**U.S. Department of Energy
Office of Environmental Management**

**Review Report: Feasibility Study
Strategies and Remedial System
Performance Improvement for the 200-
ZP-1/PW-1 Operable Units at Hanford**

Office of Groundwater and Soil Remediation
Office of Environmental Management

February 9, 2007

Figure 5.1. Schematic illustrating suggested remedial approach

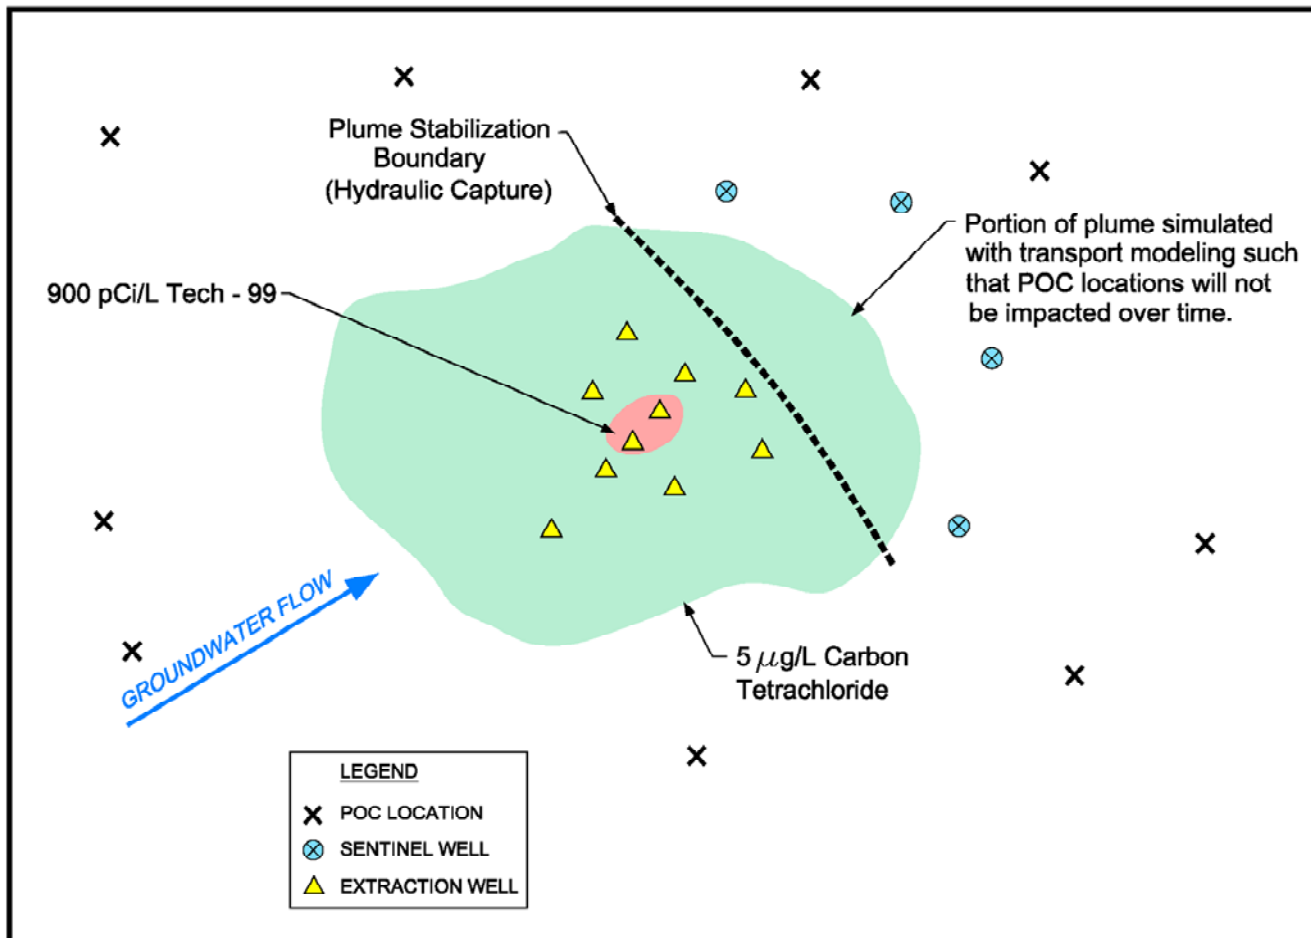
The FS may include consideration of several P&T approaches. For instance, one approach might include hydraulic containment for the full extent of the CT plume above cleanup levels. An alternate approach that may require much less capital and life-cycle cost is hydraulic containment of the most impacted portion of the CT plume, with natural remediation for the portion of the plume beyond the zone of hydraulic containment. This latter approach is schematically illustrated in Figure 5-1. The Review Team believes this latter approach will be evaluated favorably within the FS, to the extent that a combination of modeling and monitoring is incorporated to demonstrate long-term protectiveness at point of compliance (POC) locations.

Deciding on a specific boundary for the zone of hydraulic containment, the Target Capture Zone, will consider several factors:

- The Target Capture Zone should be located beyond any locations where potential DNAPL is suspected. In this manner, the groundwater downgradient from the zone of hydraulic containment should decrease in contaminant concentration over time by reducing source contribution through hydraulic containment.

- The Target Capture Zone should specify depths, or hydrostratigraphic units, where horizontal capture is required. Specifically, the Review Team noted that contamination within the Ringold Unit A, below the Ringold Lower Mud Unit, was not clearly indicated in some presentations regarding contaminant distribution. The Target Capture Zone should clearly indicate the extent to which horizontal capture in this unit is required.

- Contamination downgradient of the Target Capture Zone, CT and other contaminants, should attenuate to cleanup levels before reaching the POC locations (selection of POC locations is discussed below). For the FS, the Review Team recommends the use of simple transport models (see Section 5.3.3) to evaluate attenuation of contaminant concentrations between the Target Capture Zone and the POC locations. This exercise will help establish an appropriate location for the boundary of the Target Capture Zone, which combines an acceptable combination of distance to the POC locations and acceptable initial concentration outside the Target Capture Zone.

As discussed in Section 5.2.3, one remedial approach favored by the Review Team is to use groundwater extraction for hydraulic containment of the most impacted portion of the CT plume, with natural remediation for the portion of the plume beyond the zone of hydraulic containment (schematically illustrated previously in Figure 5.1).
